APPLICATION NO.	FILING DATE	FIRST NAMED INVENTOR	ATTORNEY DOCKET NO.	CONFIRMATION NO.
10/576,215	05/31/2006	David Magda Eddy Cortnen	PPI-14102/08	7008
25006 7590 10/27/2009 GIFTORD, KRASS, SPRINKLE, ANDERSON & CITKOWSKI, P.C. PO BOX 7021 TROY, MI 48007-7021				
EXAMINER MCALISTER, WILLIAM M				
ART UNIT 3753		PAPER NUMBER		
MAIL DATE 10/27/2009		DELIVERY MODE PAPER

Office Action Summary

DETAILED ACTION

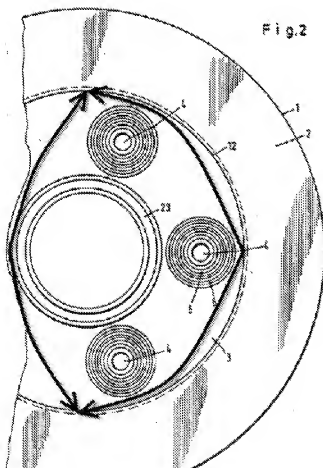
6. Claims 1-3, 5, 6, 9-15, 17, 18, 21 and 22 are rejected under 35 U.S.C. 112, second paragraph, as being indefinite for failing to particularly point out and distinctly claim the subject matter which applicant regards as the invention. Claims 1 and 13 require "a side wall extending radially from said open end to said closed end..." The only wall between the open and closed ends is illustrated with an arrow in the Figure below.

This wall is cylindrical, with its cylindrical axis extending vertically from the open end to the closed end (i.e., from top to bottom as depicted in this Figure). That is, the wall extends in an axial direction from the open end to the closed end. How does the wall extend radially from the open end to the closed end?
